7.0 Instrumentation and Control Systems

The information in this section of the reference ABWR DCD, including all subsections and tables, and figures, is incorporated by reference with the following departures and supplements.

STD DEP T1 3.4-1 (Figure 7.1-1, 7.1-2)

Figure 7.1-1 ~~SSLC Self-Test System~~ Diagnosis

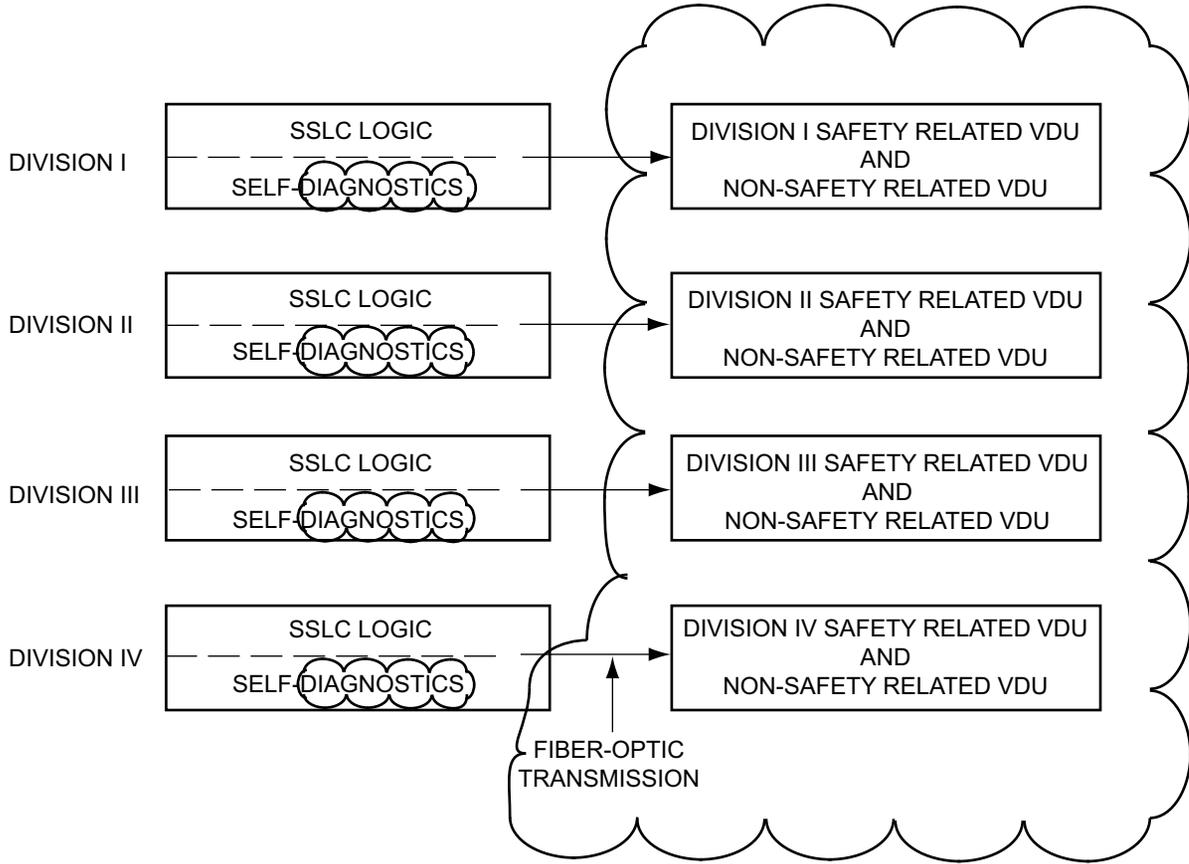
STD DEP T1 3.4-1

Each individual safety-related system utilizes redundant channels of safety-related instruments for initiating safety action. The automatic decision making and trip logic functions associated with the safety action of several safety-related nuclear steam supply systems (NSSS) are accomplished by ~~a four-division correlated and separated protection logic complex called the safety system logic and control (SSLC)~~. The SSLC includes multiple redundant divisions, which are separated from each other. The SSLC has four redundant divisions of sensors. Each division of sensors has a corresponding division that determines the trip status of the safety functions relative to the safety function setpoint. The SSLC has four redundant divisions for all actuation functions except for the engineered safety features. The engineered safety features have three divisions, corresponding to the maximum redundancy of the engineered safety features actuated components. Some engineered safety features functions are less than three-fold redundant and are assigned to the appropriate set of redundant divisions. The SSLC multi-divisional complex includes divisionally separate control room and other panels which house the SSLC equipment for controlling the various safety function actuation devices. The SSLC receives input signals from the redundant

~~Divisional separation is also applied to the essential multiplexing system (EMS), which provides data highways for the sensor input to the logic units and for the logic output to the system actuators (actuated devices such as pump motors and motor operated valves). Systems which utilize the SSLC are include: (1) Reactor Protection (trip) System; (2) High Pressure Core Flooder System; (3) Residual Heat Removal System; (4) Automatic Depressurization System; (5) Leak Detection and Isolation System; (6) Suppression Pool Temperature Monitoring System; and (7) Reactor Core Isolation Cooling System. The equipment arrangement for these systems and other supporting systems is shown in Figure 7.1-2.~~
